Administrative Amendment for City of Albuquerque permit #BP-2020-27106

Re: McDonald's 4300 Osuna Rd. NE (PR 2020-004189)

RE: Amendment to Site Development Plan
McDonald's Restaurant – 4300 Osuna Rd. NE

STANDARD DETAILS

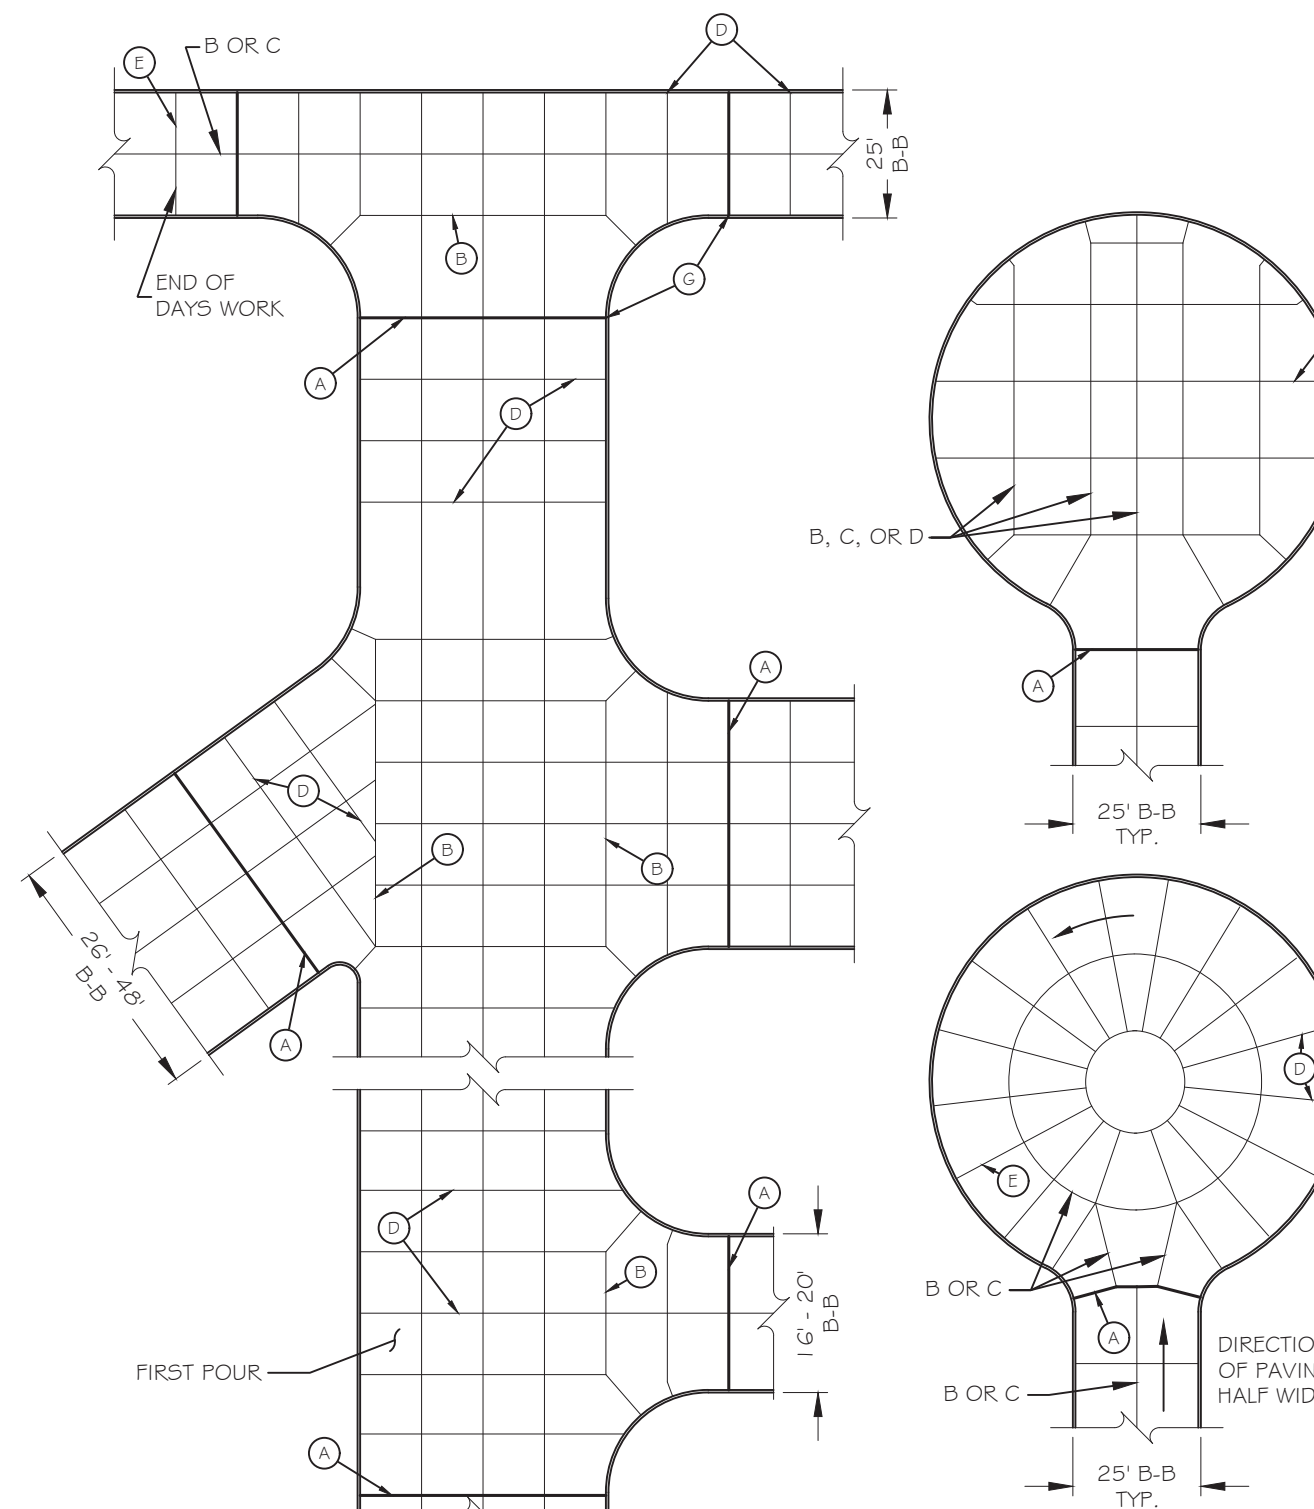
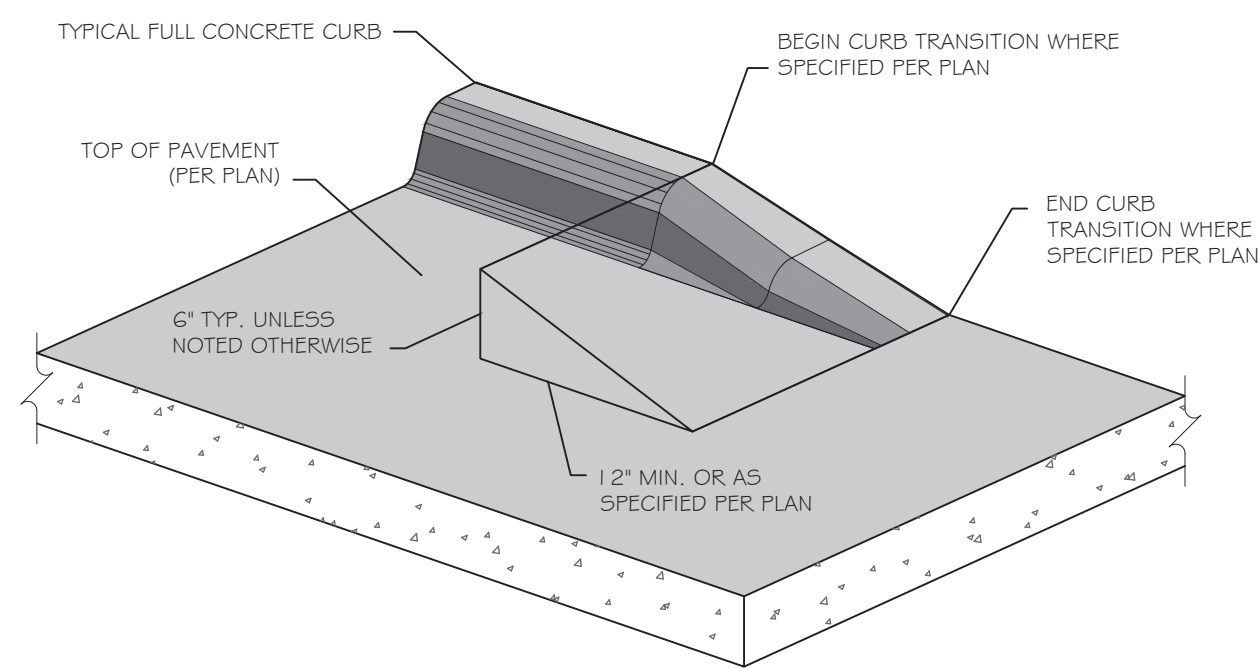
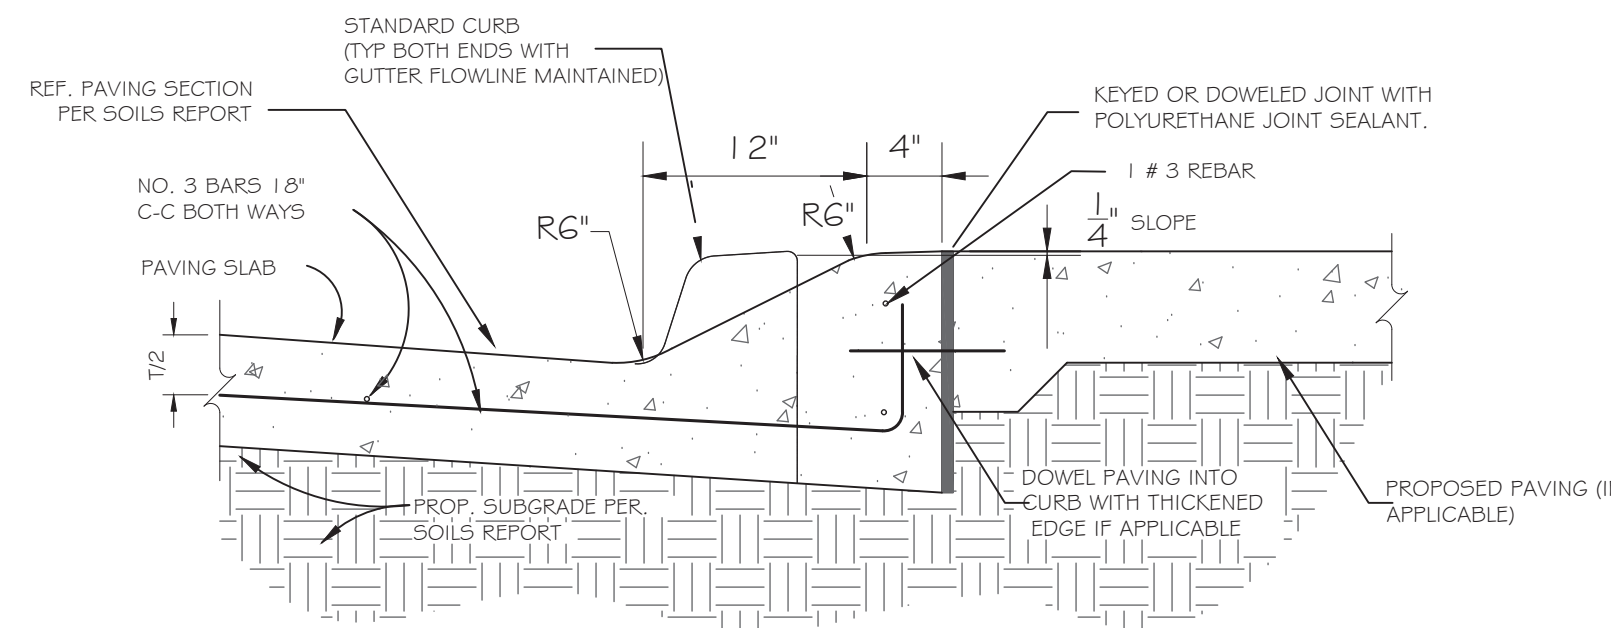
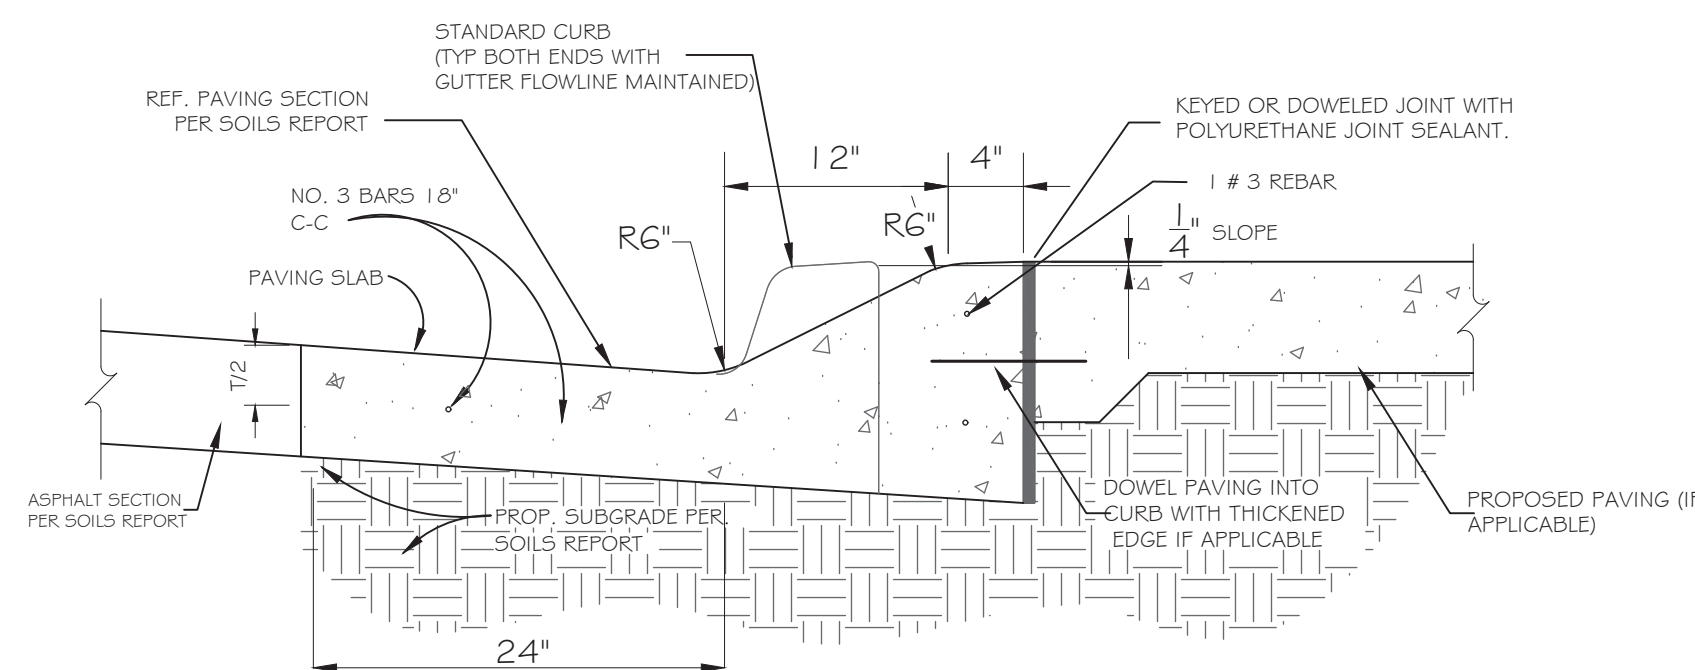
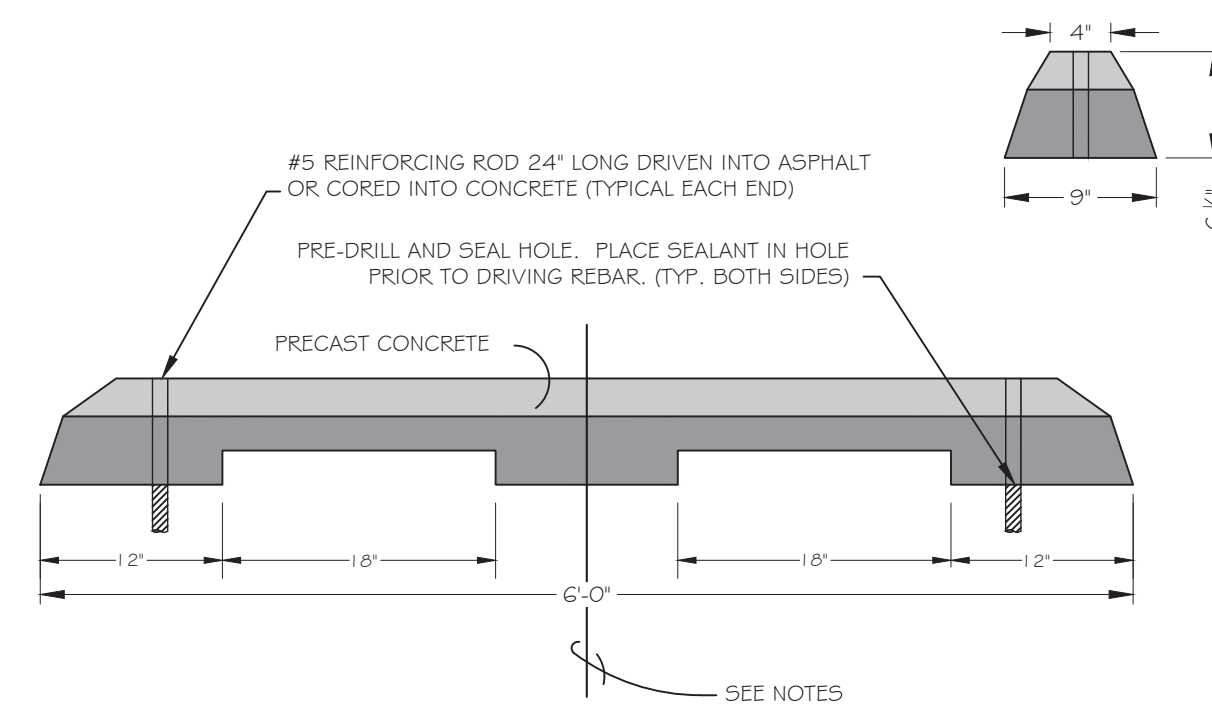
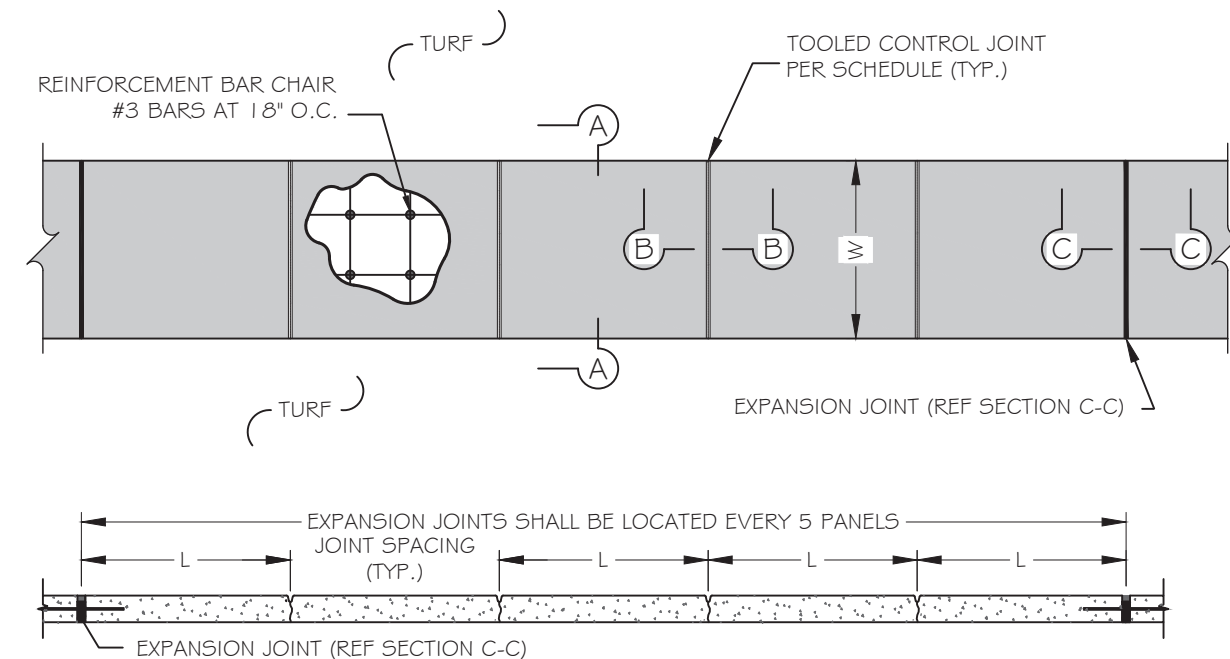
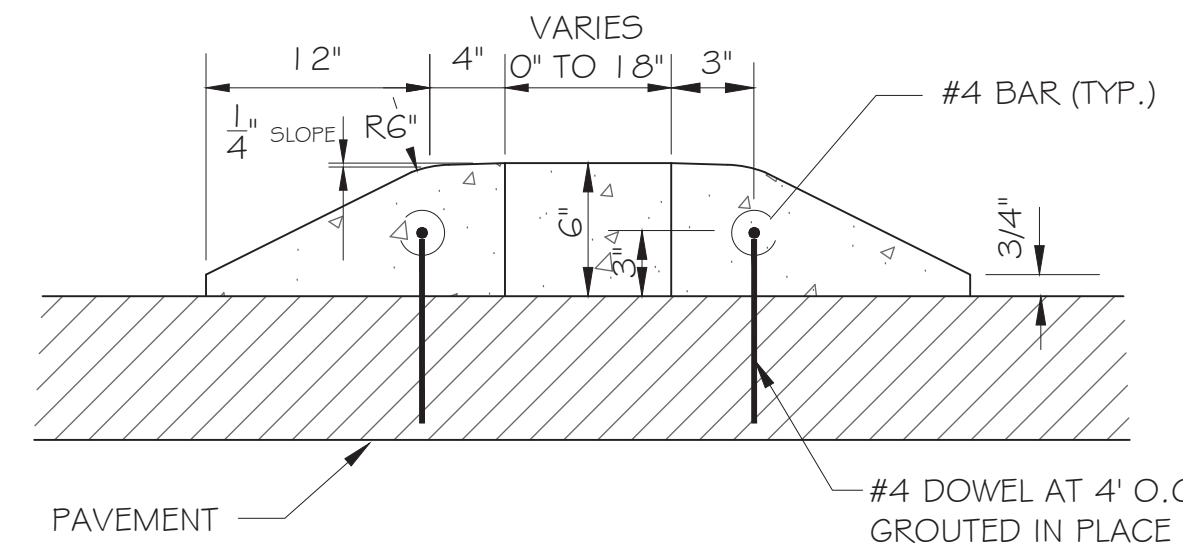
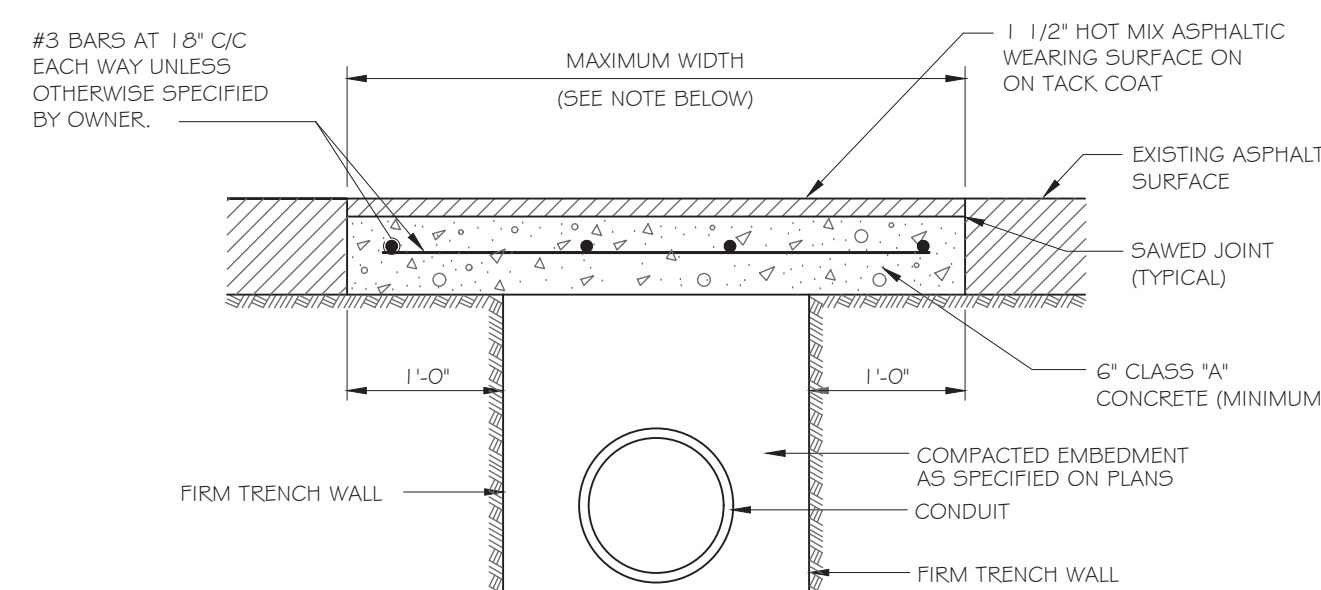
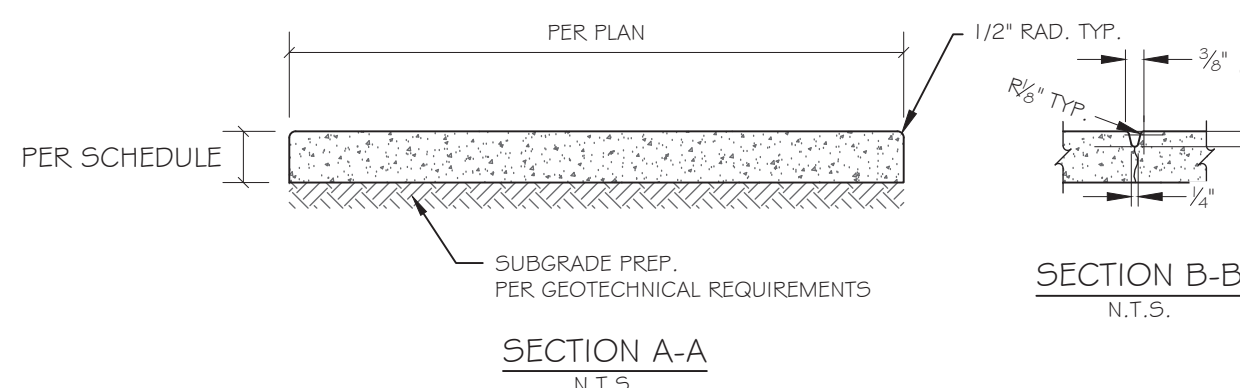
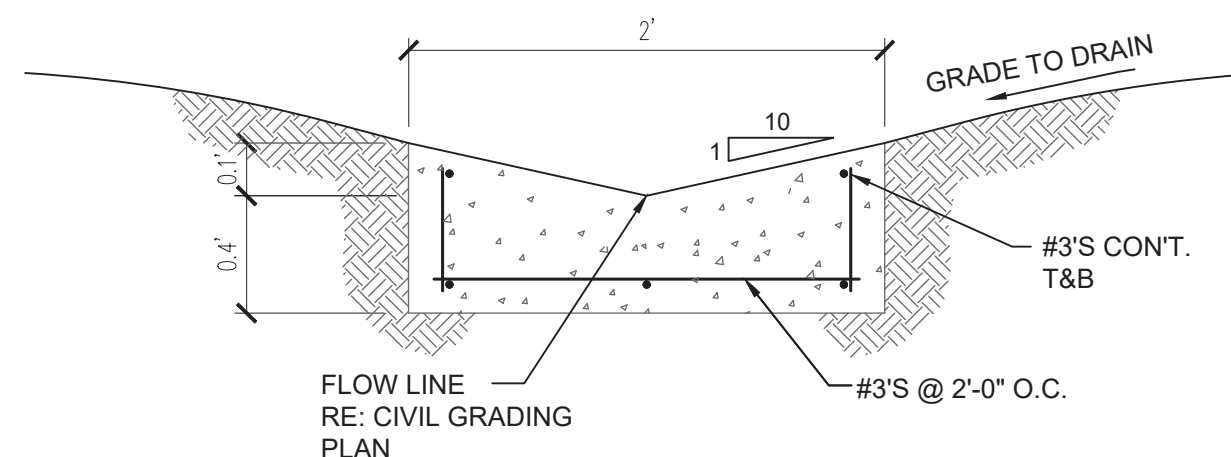
- An 11' wide van accessible space with a 5' aisle are shown in accordance with ADA Standards 502.2 and 502.3.1. See C3.0 Site & Paving Plan.
5. Include C7.1, C7.3 and C7.5 standard details as part of this set. All details for curb, sidewalk, curb ramps, and signage have to be included.

- Detail sheets have been included.
6. The ADA accessible parking sign must have the required language per 66-7-352.4C NMSA 1978 **"Violators Are Subject to a Fine and/or Towing."** Provide detail of sign.
